Access Compliance Report

Public Rights-of-Way

Intersection ID: 14340	Main Street: KENILWORTH_AV	Cross Street: GREENWOOD_CLIFF	Location:	N
ADA ID: B335412D114D	Ramp Type: BlendTrans1	Initial Pass/Fail: Pass	Overall Compliance: No	Severity Score: 7.5

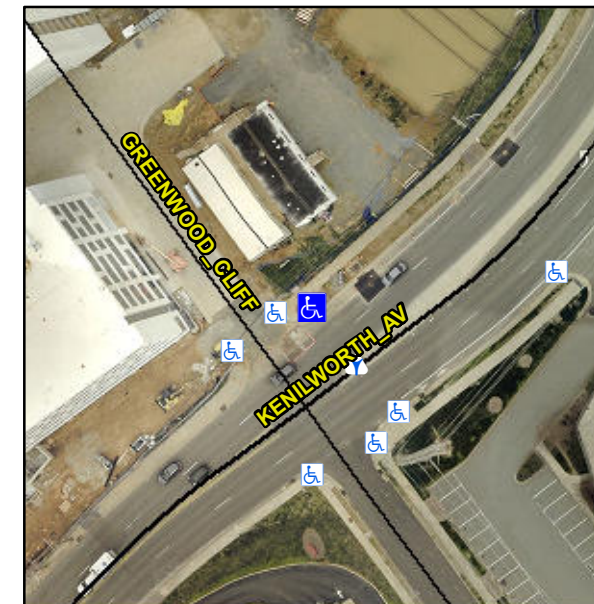
Not Found, R304.5.3, R305.2, R302.7.2

Compliance	Description	Data	Compliance	Description	Data
N/A	Ramp Length (in)	94.0	Yes	BlendTrans Slope (%)	2.3
Yes	Ramp Width (in)	48.0	Yes	BlendTrans XSlope (%)	0.7
N/A	Flare Type LT	Sloped	N/A	Flare Type RT	Sloped
Yes	Flare Slope LT (%)	6.7	N/A	Flare Slope RT (%)	5.1
N/A	Flare Traversable LT?	Yes	N/A	Flare Traversable RT?	No
Yes	Landing Length (in)	72.0	Yes	DWS Provided?	Yes
Yes	Landing Width (in)	48.0	Yes	DWS Contrast?	Yes
Yes	Landing Slope (%)	0.2	Yes	DWS Length (in)	24.5
No	Landing X Slope (%)	2.1	Yes	DWS Full Width?	Yes
N/A	Landing Curb? (Y/N)	No	No	DWS Offset (in)	5.0
N/A	Shared Landing?	No			
Yes	Gutter Ponding?	No	Yes	Gutter Slope (%)	4.0
No	Gutter Lip Ht (in)	0.3	Yes	Gutter X Slope (%)	0.6
N/A	Painted X Walk1?	No	N/A	Painted X Walk2?	N/A
	X Walk 1 Direction	To SE		X Walk 2 Direction	N/A
	X Walk 1 Width (in)	N/A		X Walk 2 Width (in)	N/A
	X Walk 1 Slope (%)	2.4		X Walk 2 Slope (%)	N/A
	X Walk 1 X Slope (%)	0.9		X Walk 2 X Slope (%)	N/A

N/A	Ramp inside XWalk1?	N/A	N/A	Ramp inside XWalk2?	N/A
	Road Slope (%)	0.9		Clear Space?	Yes
	Road X Slope (%)	2.4	N/A	Clear Space to XWalk (in)	N/A
Yes	Any Obstructions?	No	Yes	Storm Grate/Utility Hazard?	No
	Obstruction Type			Storm Grate/Utility Type	
		N/A			N/A
			Yes	Surface Condition? (G/P)	Good
			No	Curb Slope (%)	11.9

Remove & Replace Curb Ramp With Two New Directional Ramps or Equivalent.
